Technical note

Project:	A428 Study - Phase 2	To:	Adrian Shepherd
Subject:	Analysis of Consultation Proposals	From:	Atkins
Date:	1 Feb 2016	cc:	Ashley Heller

The aim of this technical note is to provide an initial analysis of the alternative proposals received as part of the public consultation on the A428 Cambourne to Cambridge Better Bus Journeys scheme. This technical note is a supporting document as part of the report to the City Deal Partnership on the outcome of the public consultation undertaken in the autumn of 2015. The written representations considered within this technical note will, as required be assessed as part of the appraisal of options and feasibility for the scheme

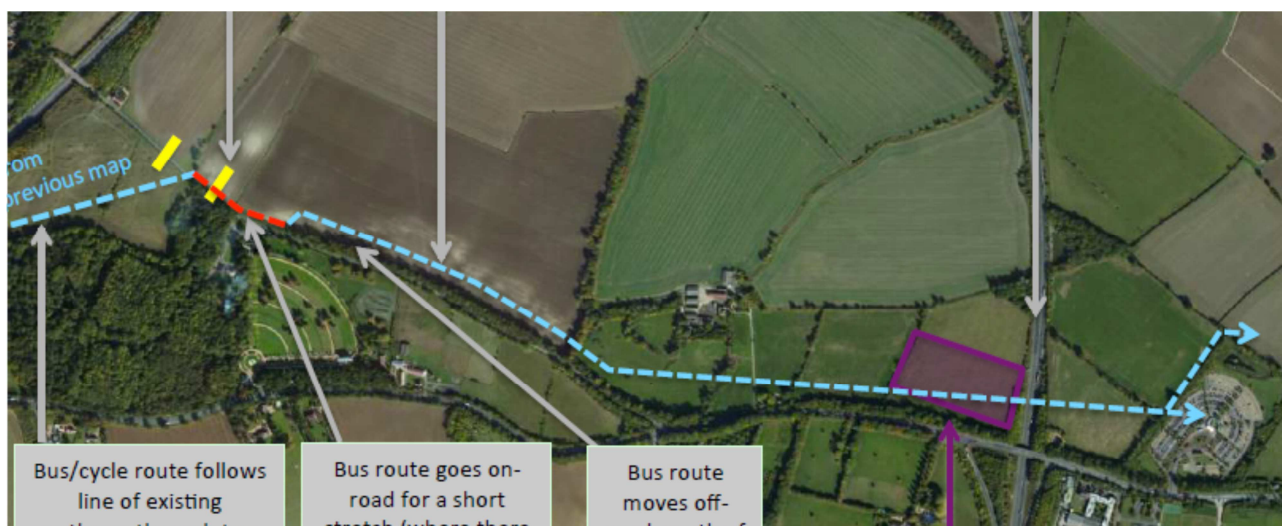
The respondents' proposed route is depicted on their maps below, and includes a bus-only shortcut before the Madingley Mulch roundabout, routing along the top of the A428 embankment and just south of the 800 wood, and then continuing north of Cambridge Road, across the M11 using a new structure and into the existing Madingley Road Park and Ride.

Benefits listed by the consultee include: high reliability due to offline route, minimising environmental impact by placing route between 800 Wood and Madingley Wood SSSI, avoids M11 J13 bridge.

This proposal has many similarities with Option 1 North. Many of the elements proposed are detailed features which could be considered in future stages of scheme development should Option 1 North be selected as an option to be taken to a subsequent stage of scheme development following the Board's consideration of the outline business case analysis.

- The bus-only short cut to avoid the roundabout: the requirement for this short-cut may depend on the exact location of a P&R at Madingley Mulch. If this particular alignment is deemed to offer benefits, it will be examined during scheme development, as considerations such as levels, sight lines and bus turning radii will inform its feasibility.

- Access restrictions to Church Lane: even with resident passes (required for all car owners of Madingley and potentially Dry Drayton), operational considerations such as access for visitors, deliveries and emergency services may mean that restricting access is unfeasible. Other mitigation measures to limit impact of traffic on Church Lane should also be considered.

- Routing along the embankment: the requirement for this route may depend on the exact location of a P&R at Madingley Mulch. If beneficial, an assessment of the suitability of this alignment should be carried out during subsequent stages of scheme development. Considerations such as topography, environmental impacts and proximity to the American cemetery will inform the feasibility of this alignment.

- Route through 800 Wood: the extent by which a single rather than double lanes will reduce impact on the wood should be considered during subsequent stages of scheme development should this route be chosen.

- On-road bus route: the benefits of having this section of the route on-road are not explicitly stated, but it will limit journey time reliability if included in the route as presented.

- Bus-only route immediately north of Cambridge Road: this alignment could be considered as part of ongoing assessment, however initial considerations indicate Cambridge road may need upgrading and safety barriers installed for the bus/cycle route to run 2m lower than the existing road. If required a RRRAP (Road Restraint Risk Assessment Process) assessment would ascertain containment type.

- Future-proofing P&R site: should the existing site need be replaced a study to assess alternative arrangements would identify suitable sites
- New bridge over the M11: a new structure is likely to incur high costs, but will also remove the constraint of limited crossings over the M11. The ratio of benefits and costs associated with

achieving this potential benefit is assessed as part of the business case via a sensitivity test on Options 1 Central and 1 North

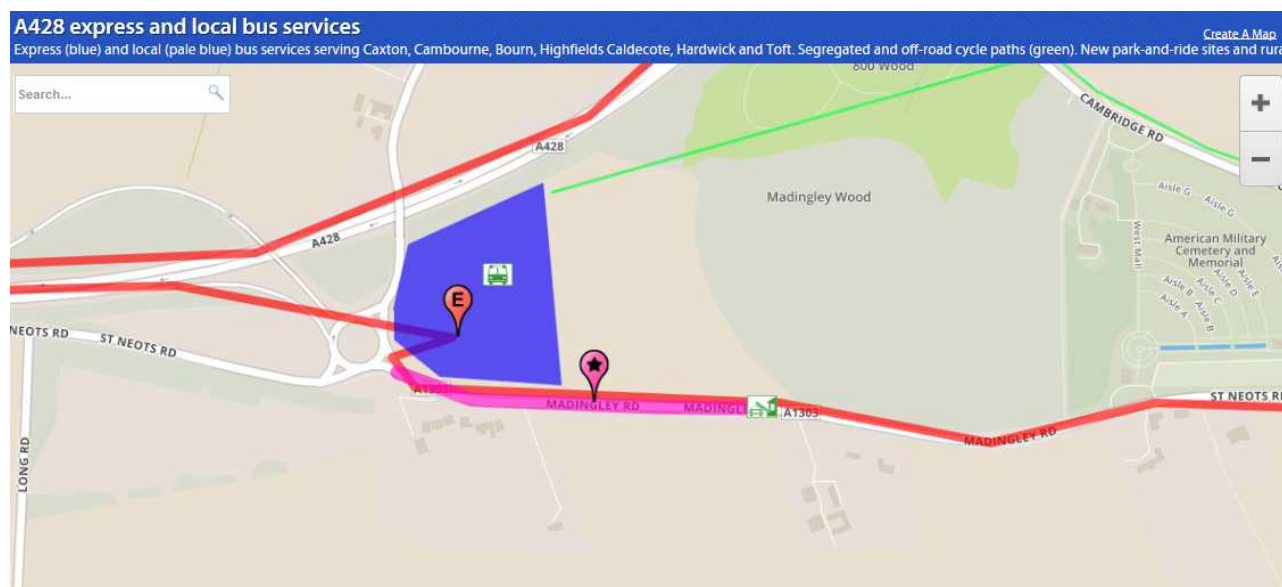
These proposals involve using similar infrastructure to that proposed for Options 1 Central and 1 North for the Madingley Hill section of the route. Once buses have crossed the M11 using the existing route, they would enter the West Cambridge site and continue towards Grange Road by means of a possible combination of a segregated route and roadway.

The main benefit listed by promoters of this proposal is the use of the existing M11 bridge, thereby eliminating the need for a new structure, while still retaining some of the benefits of offline segregation of Option 1 South. Limiting the impact to Coton is also listed as an advantage.

As proponents described, this route albeit a compromise of two options may potentially realise some of the benefits of off-line alignment while limiting the overall scheme cost, as a new bridge over the M11 would not be required.

The route through West Cambridge also has the potential for increased patronage should development at this location continue. A bus stop might be located towards the centre of the site and may therefore attract more users than that on Madingley Road.

Adams Road and Herschel Road are perhaps two of a number of potential locations where this route's exit onto Grange Road could be achieved. Initial assessment indicates the need for complementary on street measures.

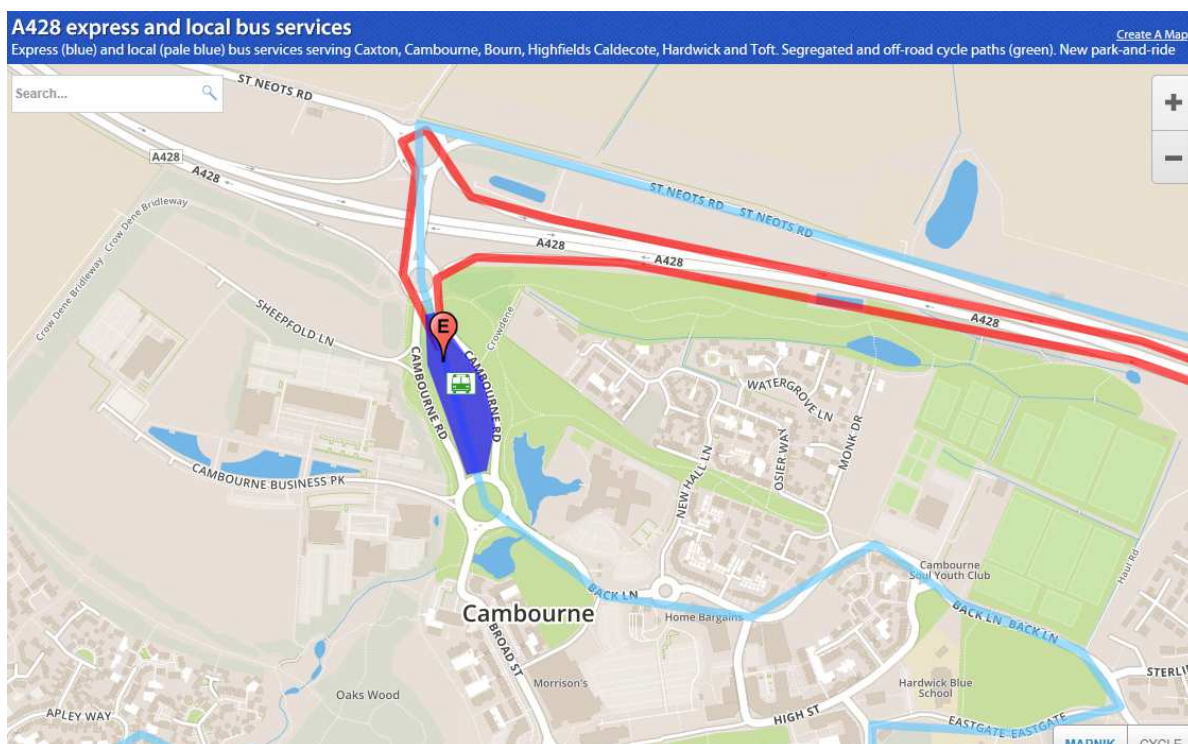
This proposal as understood involves using signals to regulate traffic flow into the City. Construction of a 500m queuing lane on Madingley Hill and a similar one on the M11 slip road are proposed for traffic to wait until access is provided. A bypass lane for the bus would be introduced at this location.

The map below shows the proposed bus route (in red) and the location where road widening would be required to accommodate the queuing lane (in pink).

Note the lane diagram above is our interpretation of how the queuing and bypass lanes would be arranged at this location.

As proponents described, this arrangement can help regulate flow. However, the proposed measures do not reduce congestion but instead relocate it. As a result, the proposal is unlikely to support growth, one of the City Deal objectives.

Widening the existing road to provide queuing space is not an effective use of the highway, which instead could be widened to provide a bus lane. If buses share road space with other traffic once past the queuing locations, mode switch will not be encouraged to the same extent as in the original proposals.

For the bypass lane to be as effective as a bus lane, regular traffic would need to be held back until the entire length of the queue clears (usually from the M11 to Madingley Hill), otherwise buses would travel past the signals and immediately encounter the back of the following queue. Holding back traffic to this extent would lead to very high queuing times and queue lengths, and it is likely that traffic would relocate to other radial routes. Long queue lengths may also tail back to the M11 or A428, where they may pose a safety risks for both drivers in the queue and other road users.

The assessment of queue space required included in the proposal assumes that queuing space should be proportionate to the length of the congested route. This assessment assumes traffic is completely stationary, which is not correct. Since traffic is flowing (albeit slowly) the assessment should be based on flow, not route length.

For example, if the flow on Milton Road is 1000 vehicles/hour, 20% of that is 200 vehicles which each need 6m to stack giving 1.2km of new carriageway to provide. This is four times the length identified in the example worked through by the proposer.

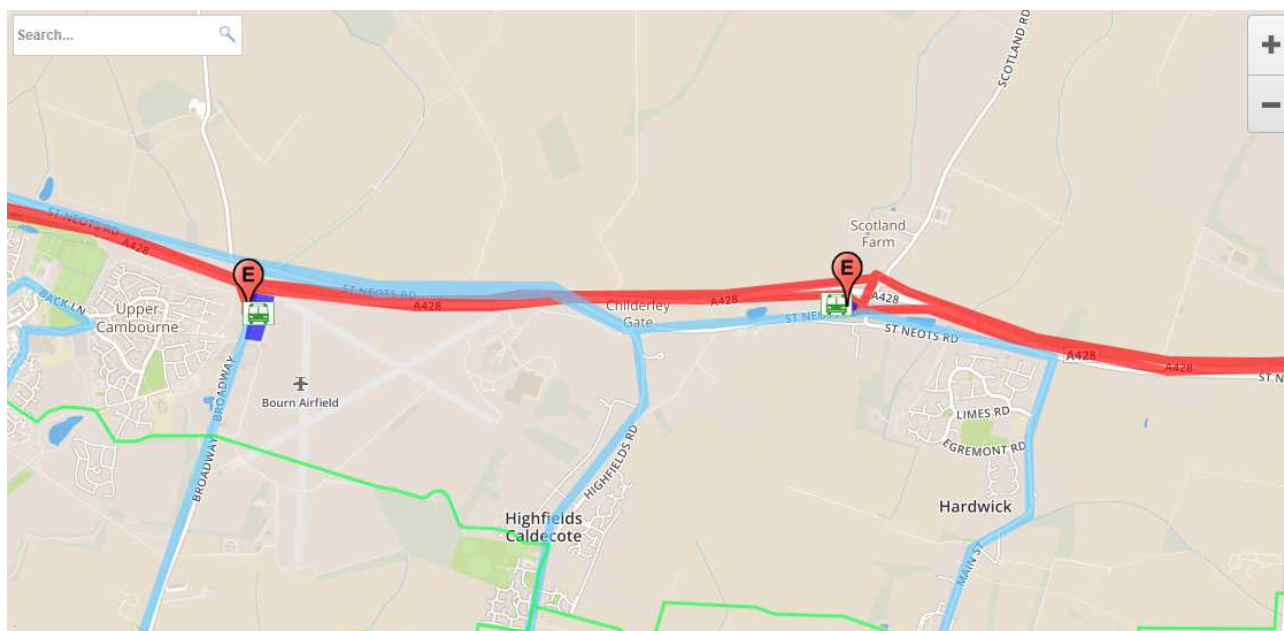
This proposal involves the creation of a new Park and Ride in the vicinity of Cambourne. Two potential locations have been suggested: between the two roundabouts south of the A428 access, and north of the junction with the A428.

Note the area in the second image has been shaded based on Atkins interpretation of the description in the alternative proposal.

With regards to interception, considerations are similar to those listed in section 4.1.2 above, which states driver behaviour will likely limit mode switch for P&Rs located at points where congestion is not visible.

Walk-and-ride patronage from Cambourne will be present, but this could also be achieved by providing bus stops in Cambourne. Interception of vehicles further east than Cambourne will only be possible at the Madingley Road P&R, and congestion on Madingley Hill is likely to persist as a result.

Operation costs are also likely to be higher for Park and Rides further from the end of the bus route, as more buses will be required to operate the same route, and result in economic dis-benefits when compared to a closer location. The magnitude of this effect cannot be quantitatively assessed without further analysis.

These three considerations indicate that locating a Park and Ride at Cambourne will be less beneficial than locating it further east (e.g. at Madingley Mulch and Scotland Farm), where the congestion starts, patronage will likely be higher and operating costs are lower.

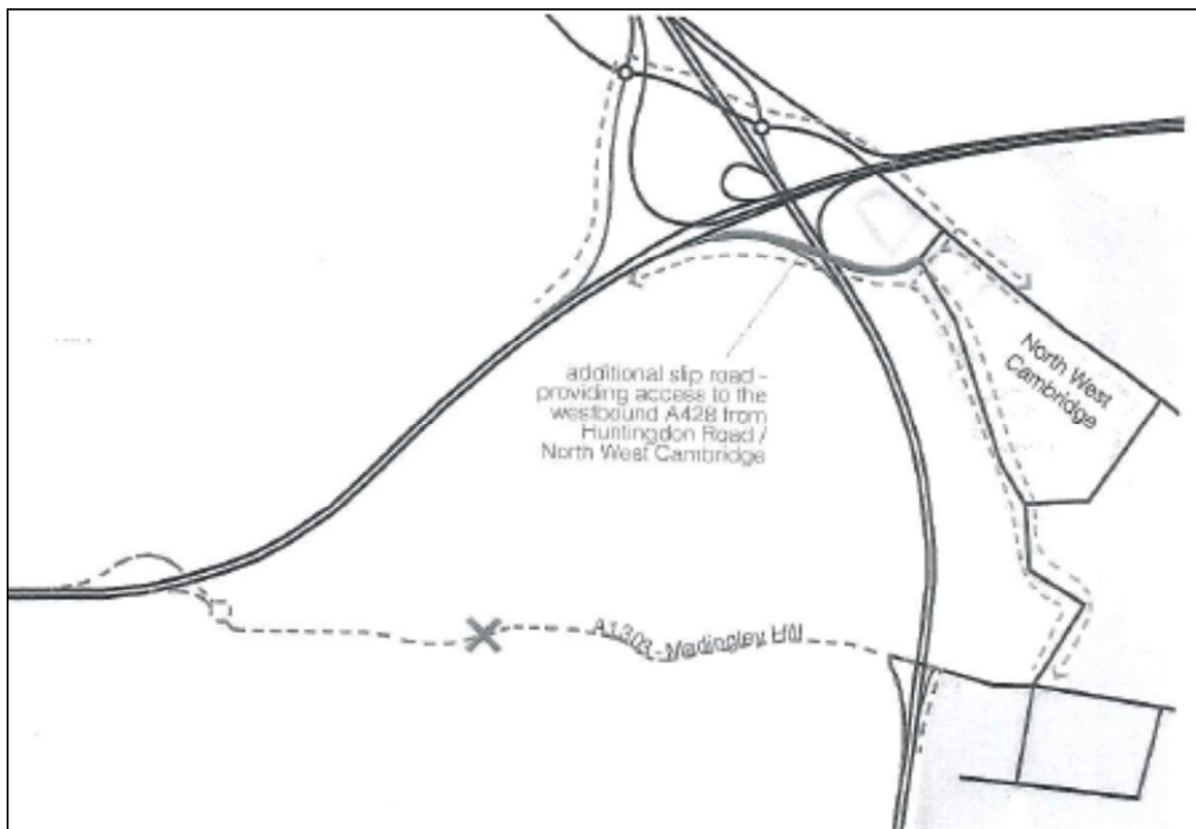
This proposal involves the creation of transport hubs at Cambourne, Bourn and between Highfields and Caldecote. These transport hubs would have “facilities similar to a train station”.

Similar considerations to those listed in sections 4.1.2 and 4.8.2 above apply. In addition, these transport hubs are likely to have poorer accessibility as they are located off the old A428 road (St. Neots Road). A bus route with local stops is likely more efficient to operate than several small Park and Ride sites.

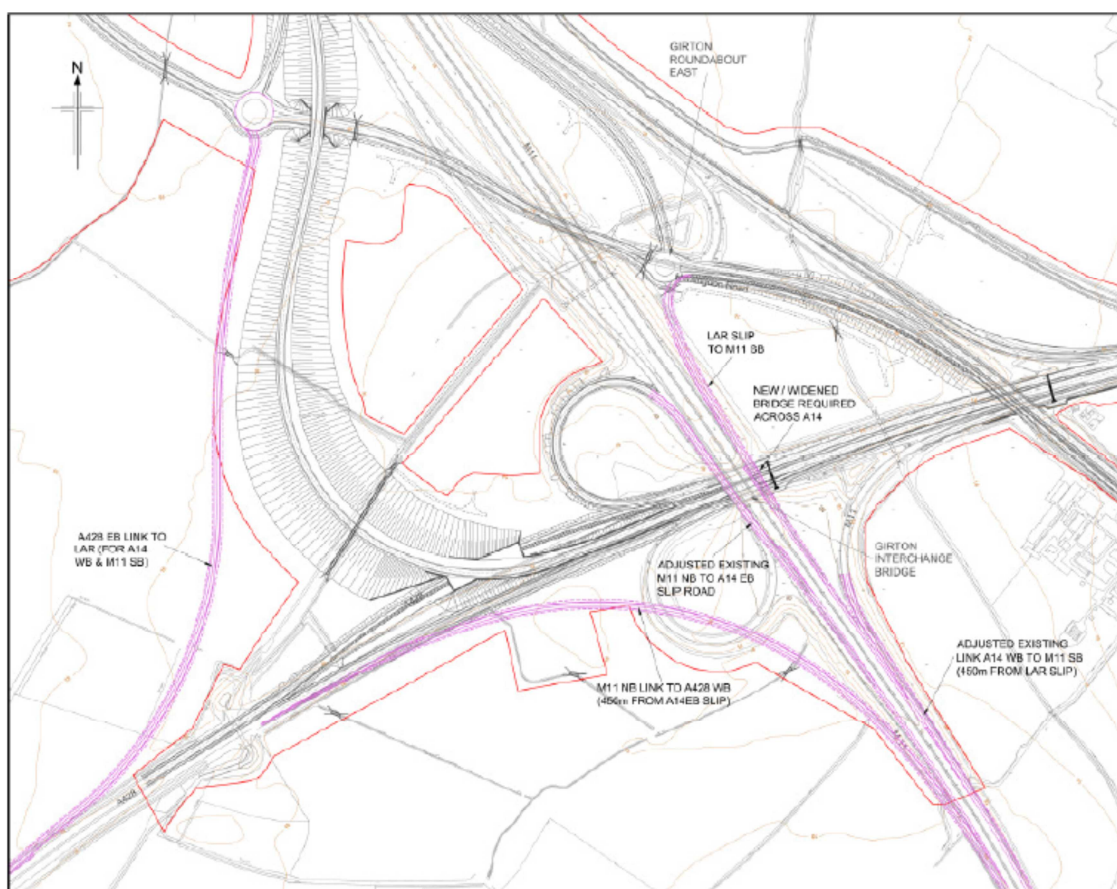
This proposal involves closing Maddingley Hill to through-traffic and using the existing road space to provide a busway. It should be pointed out that it assumes full connectivity at the Girton interchange, as depicted below.

Development of the Girton interchange is necessary for this option to be feasible. Current discussions with Highways England indicate amendments to the interchange are not programmed for the foreseeable future. Without developments to the Girton interchange, which are outside the scope of the project, this option would worsen congestion and accessibility, and as such would not meet the transport objectives.
